NAKAMICHI

Model Nakamichi 630 (FM Tuner Preampfier)  
Serial No. from 4203553  
Subject Modification on Usable Sensitivity  
of Tuner Section

No. NR-0013 (1/5)  
Date 1 September, 1977

Fig. 1

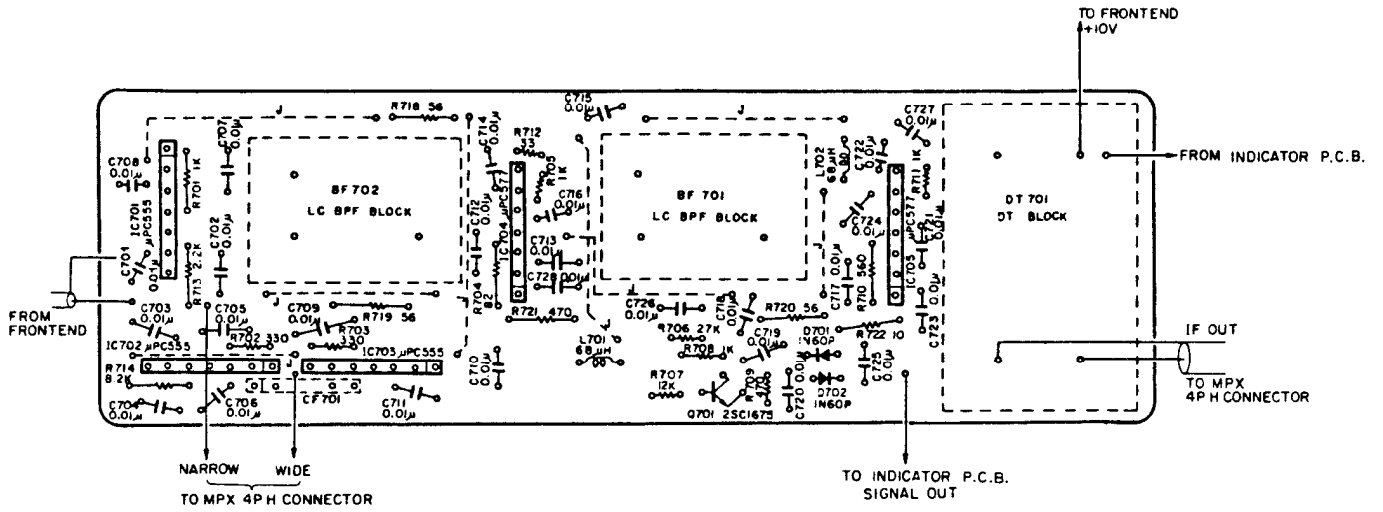
This alteration led to improvement of limiter characteristics (from 3 stages to 6 stages). As a result the AGC line was eliminated due to needlessness of AGC resulting from quick limiter activation.

I.F. Block Ass'y (Part No.:JA03167A) has been replaced with I.F. Block Ass'y B (JA03178A) and Indicator P.C.B. Ass'y (BA03832A) with indicator Ass'y B (BA03861A).

7. Assemble the new I.F. Block Ass'y B and the new Indicator P.C.B. Ass'y B, then reconnect these signal wires in the same manner as for the current connection. (Connect BRN (SIGNAL) and ORN (+10V) wires of Indicator P.C.B. Ass'y B and ORN (+10V) wire and coaxial cable (I.F. INPUT) of RF unit to I.F. Block Ass'y B.)
